CASE OFFICER'S REPORT

Application Reference:	2023/07607
Site Address:	Alderbury House, Tunnel Hill, Alderbury
Date of Inspection:	N/A
Date site notice posted:	22.09.2023
Date of press notice:	21.09.2023

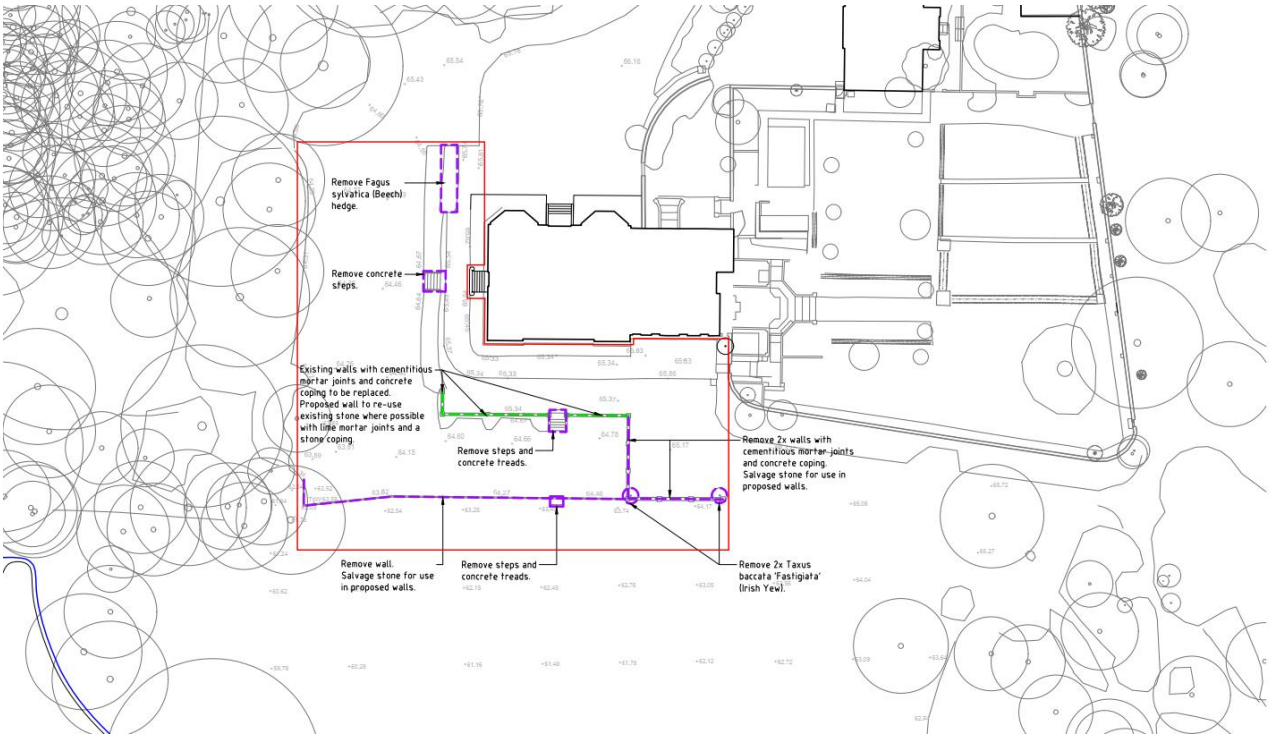
The proposals are to largely remove areas of inappropriate terracing, walling, steps and some planting to simplify the formal landscaping around the impressive Listed dwelling, as is set out below:-

Figure 15
Aerial Sketch of Proposed

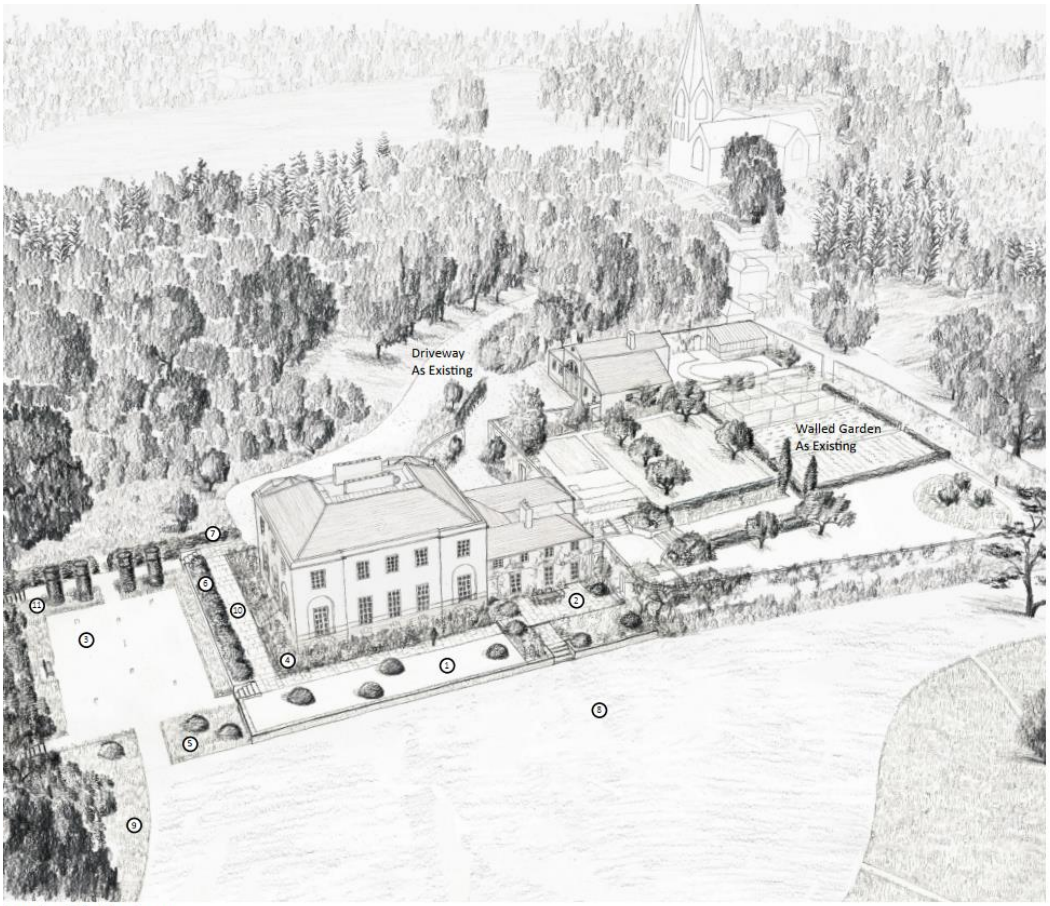
These relatively subtle changes to the site will take the setting of the Grade II* dwelling back to its original setting when first constructed in the 18th century. A visualisation of the finished proposal is as set out below:-

The Conservation Officer considers that the proposals will enhance the setting of the Listed Building, in accord with section 66 of the PLBCA Act 1990 as well as paragraph 206 of the NPPF and also confirms that Listed Building consent is not required for the works.
